Subject: Response to U.S. EPR Design Certification Application RAI No. 547 (6499, 6359), FSAR Ch. 3 - NEW PHASE 4 RAI, Supplement 6 - Part 1 of 4
Sent Date: 4/29/2013 5:18:22 PM
Received Date: 4/29/2013 5:20:57 PM
From: WILLIFORD Dennis (AREVA)

QUESTIONS for Structural Engineering Branch 2 (ESBWR/ABWR Projects) (SEB2)

Question 03.07.02-78**Open Item****Follow-up to RAI 371, Question 03.07.02-66 and RAI 376 Question 03.08.05-28.**

Figure 3.7.2-78-23: Wall 7 - Soil 1n2ue & 1n5aeh (Cracked Concrete Case)

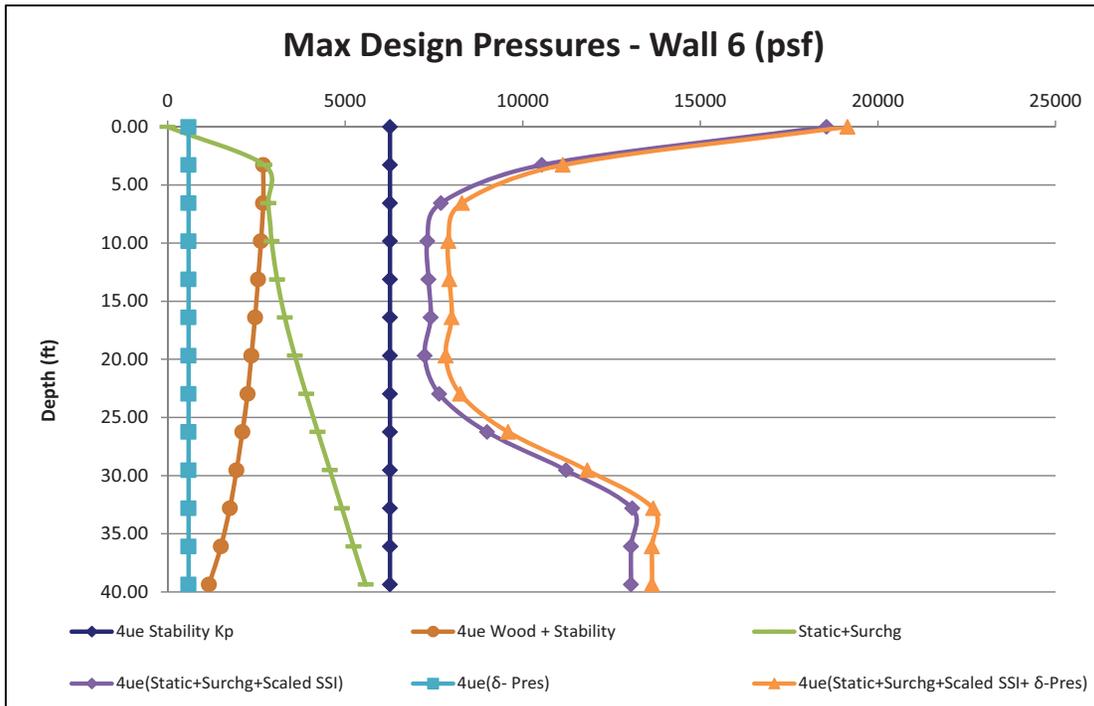
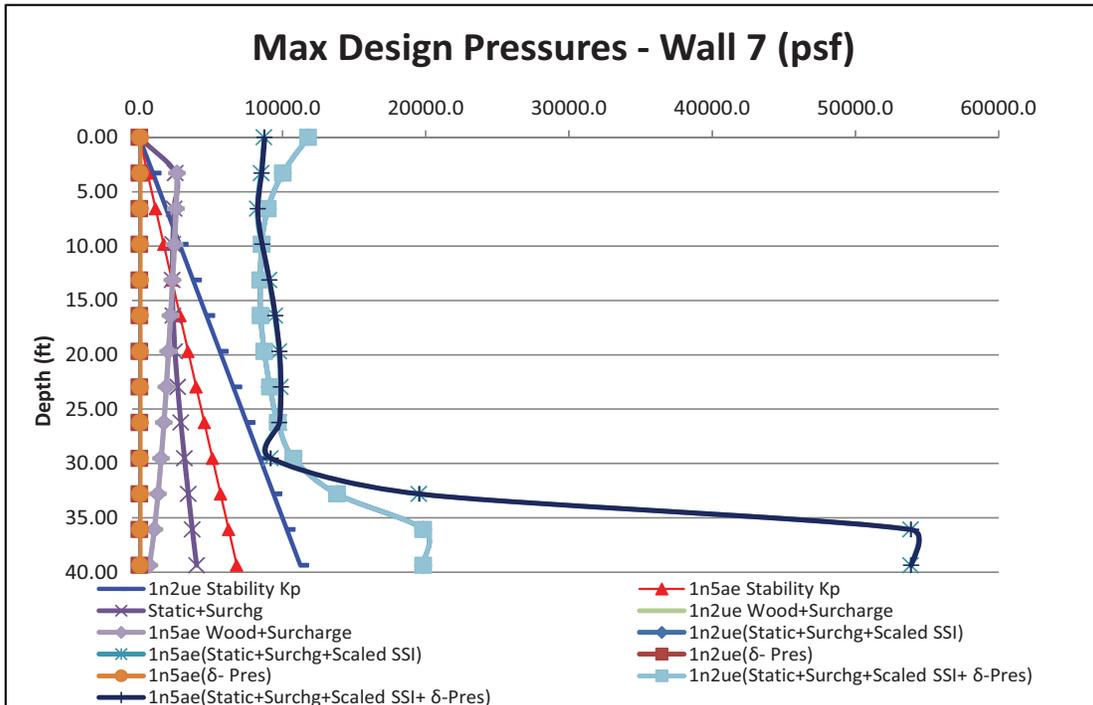
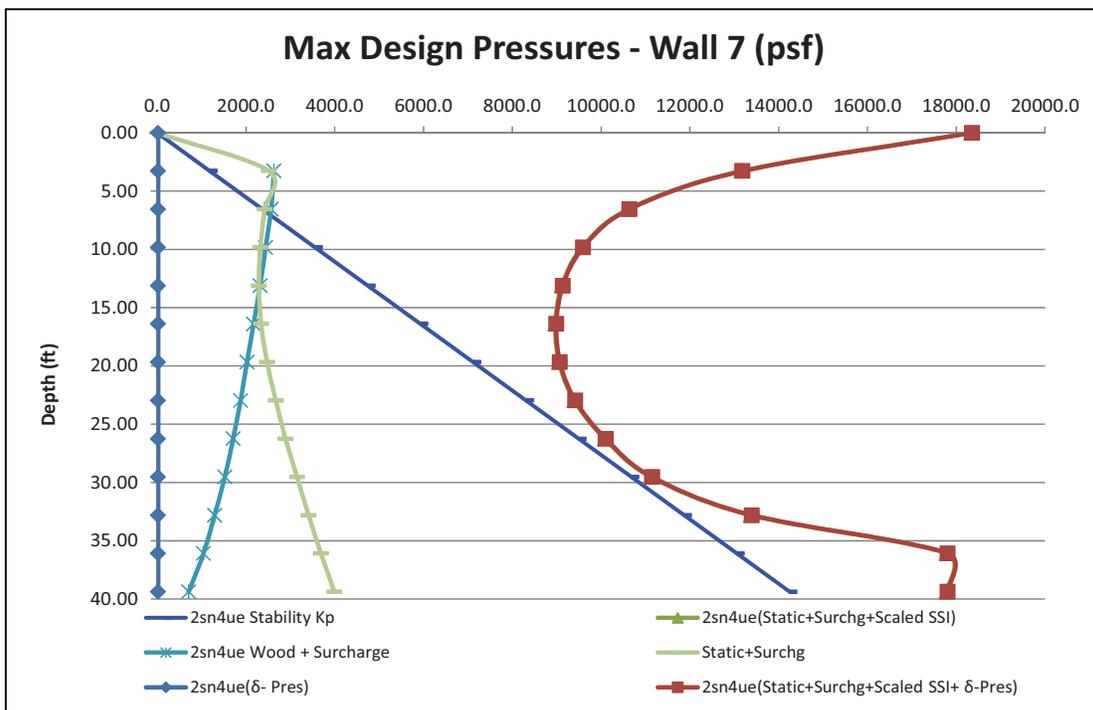
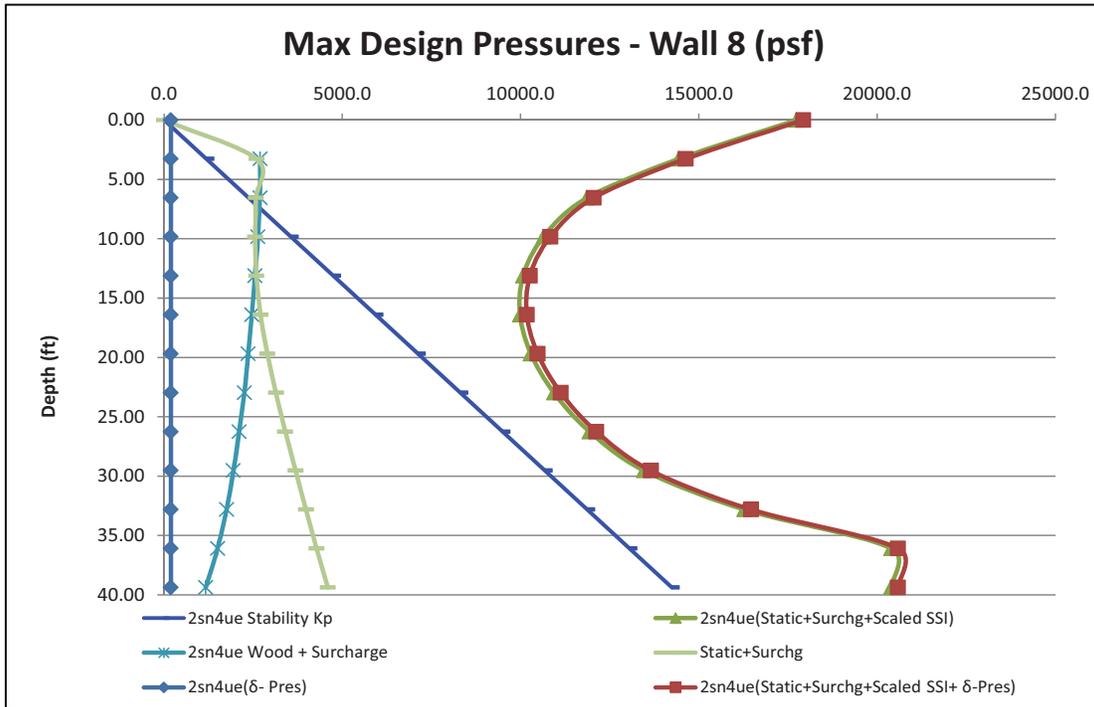
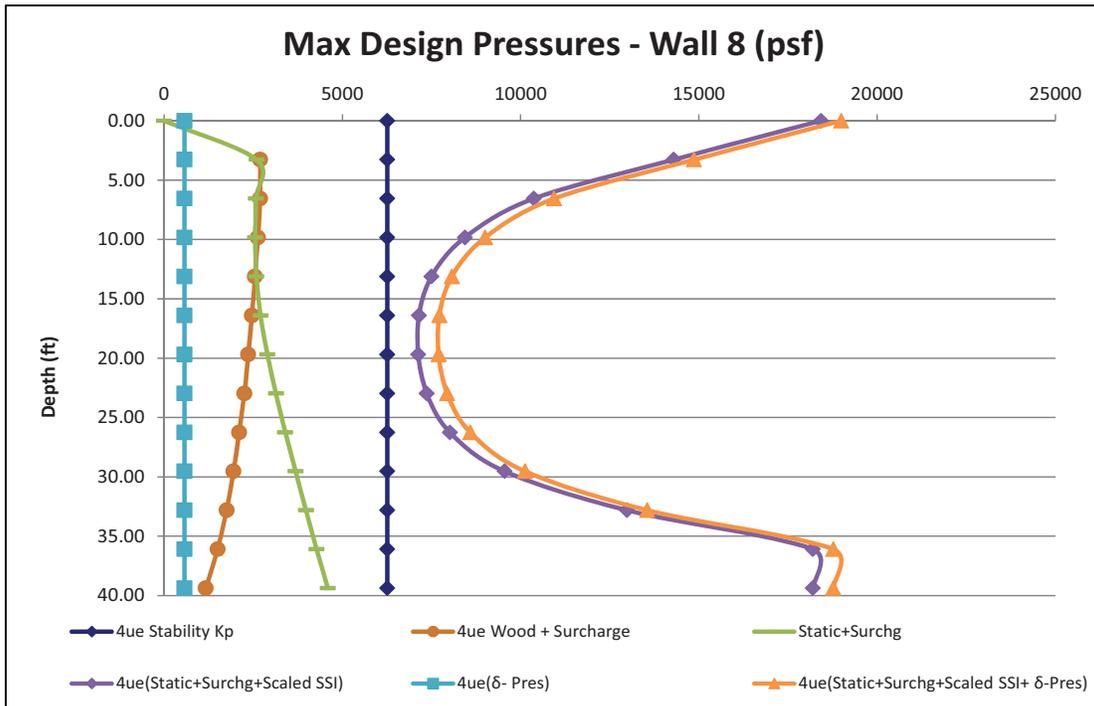
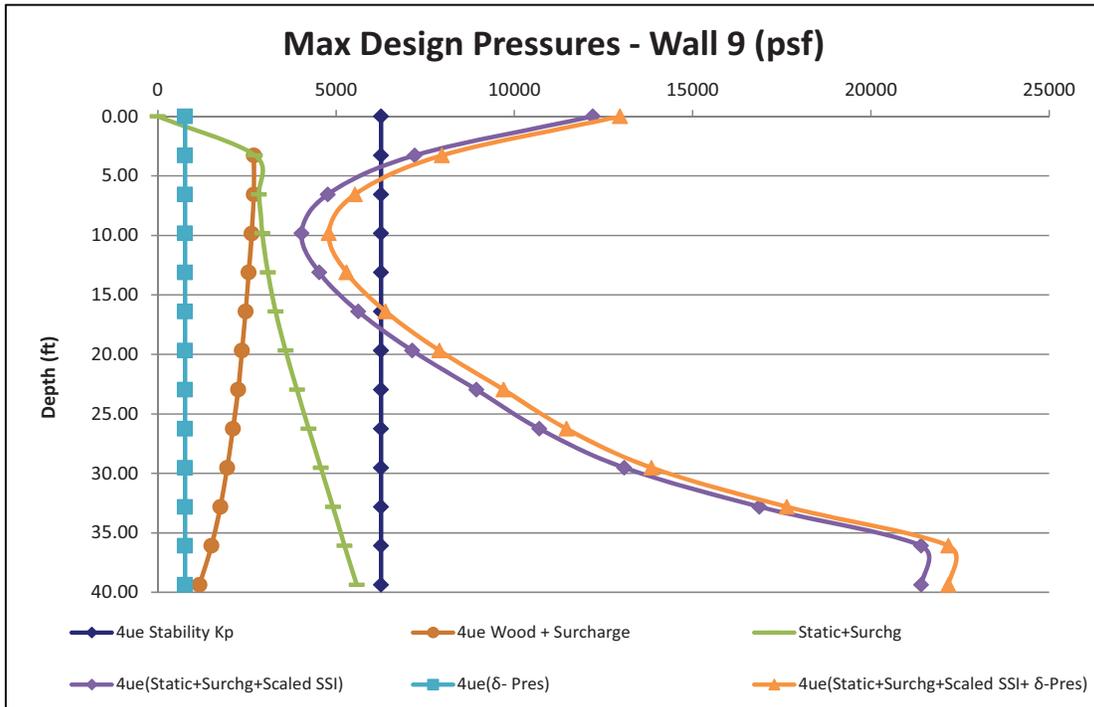
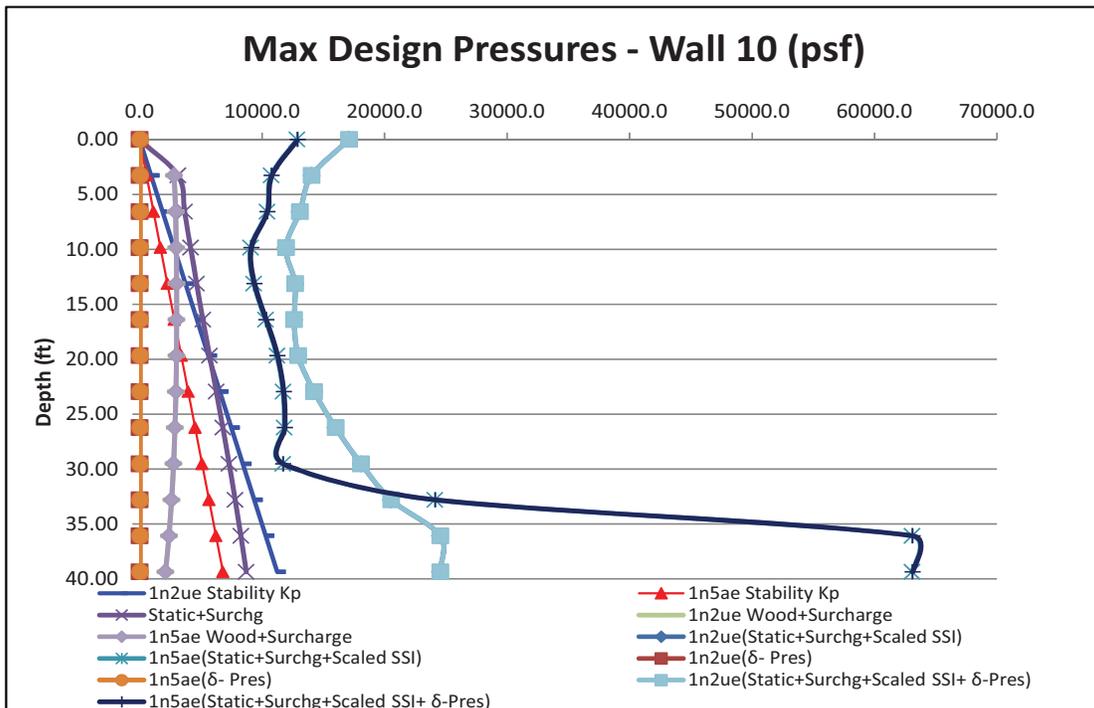
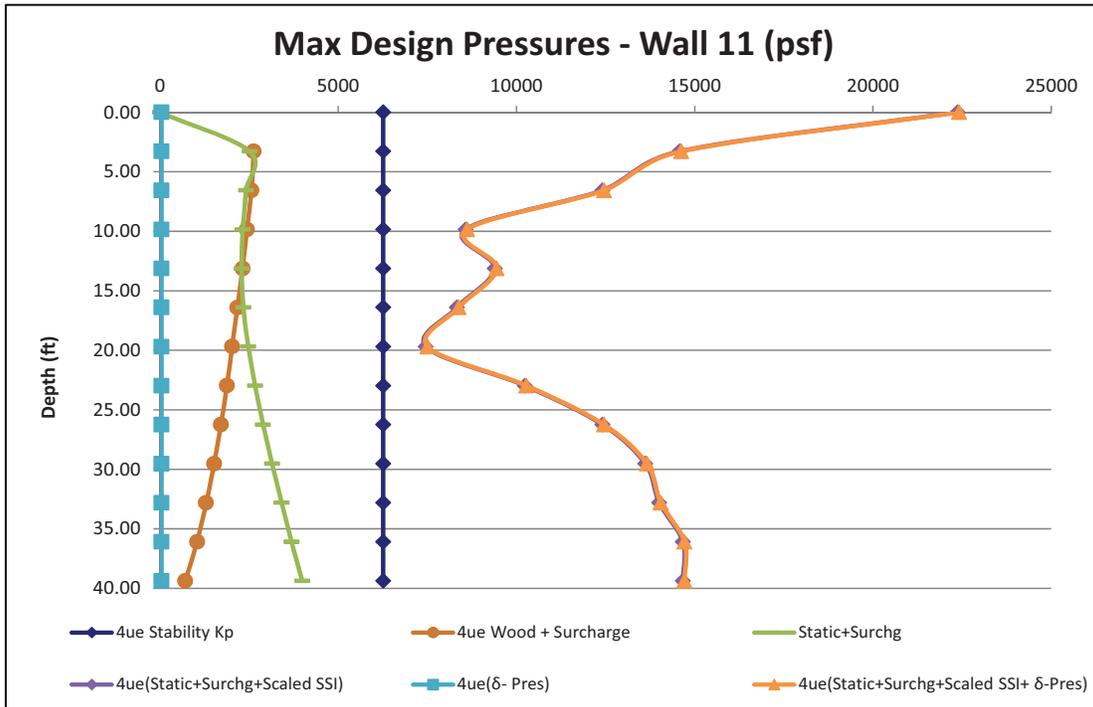
- (a) To ensure that the referenced figures in RAI 376 Question 03.08.05-28 provide a consistent comparison, confirm that all the pressure profiles shown represent the combined effect of static plus surcharge plus seismic loads, including the profiles identified as Wood's solution. How are the static and surcharge loads combined with the scaled SSI pressures and to the passive pressures from the stability analysis?

- (c) A review of the referenced figures indicates that, for a given wall, soil, and analysis case, it does not appear to be always true that the scaled SSI pressure profile always bounds the pressures required by the sliding stability analysis. For example, in Figure 03.08.05-28-5 (Wall 2, "cracked" analysis) the vertical "4uem Stability K_p " profile (blue line) is greater than the "4uem" profile (magenta line) at depths between approx. 5 ft. and 25 ft. A similar situation is observed in Figure 03.08.05-28-61 (Wall 2, "uncracked" analysis). This is due to the difference in the relative shape of the two pressure profiles. Since the applicant indicates that it is not using an envelope of all soil cases (such as the ones shown in Figures 03.08.05-28-42 through 03.08.05-28-59 and Figures 03.08.05-28-98 through 03.08.05-28-115), but is considering each soil case independently, explain how

- (d) It appears that the additional pressures due to the localized sliding/uplift of the basemat (i.e., the “delta pressures” described in the response to RAI 371 Question 03.07.02-66, listed in Tables 03.07.02-66-1 and 03.07.02-66-2) were not included in the referenced figures in RAI 376 Question 03.08.05-28. It therefore does not provide the staff with an accurate representation of the total soil pressures acting on the walls, which was the intent of the original RAI. Therefore, the applicant should provide a revised version of the figures in RAI 376 Question 03.08.05-28 that includes the SSI pressures, the delta pressures, and the combination of the two for all embedded walls including the tendon gallery. The information provided should be consistent with the information requested under Question (1) of this RAI.

- (c) The combined static, surcharge, delta pressure, and scaled SSI pressures generally bound the pressures required by the sliding stability analysis (SSI analysis). The example cited in the Response to RAI 376, Question 03.08.05-28, corresponds to the soil case 4uem for which a uniform soil pressure of 43.5 psi for the walls and 50 psi for the TG was applied to provide the minimum factor of safety for sliding. Note that for soil case 4uem, the scaled SSI pressure with static, surcharge and delta pressures do not bound the stability pressure case at certain local sections of the wall (between roughly 5 ft. and 25 ft. from the top). However, Figure 3.7.2-78-46 through Figure 3.7.2-78-55 show that other soil cases would govern the design of the walls; and, in fact, exceed the stability pressure requirements of soil case 4uem. In soil case 2sn4uem for walls 5 and 11, only minor sections of the wall were not bounded by the scaled pressures. However, the design of the wall would be governed by the larger sidewall pressures at the top and bottom of the walls where the scaled SSI pressures are significantly greater than the stability pressures.

- (d) Figure 3.7.2-78-8 through Figure 3.7.2-78-37 show the stability (K_p); static and surcharge; Wood's and surcharge; static, surcharge, scaled SSI and additional (delta) pressure due to localized sliding/uplift of the basemat; and the combined delta pressure, scaled SSI, static and surcharge for the embedded walls.
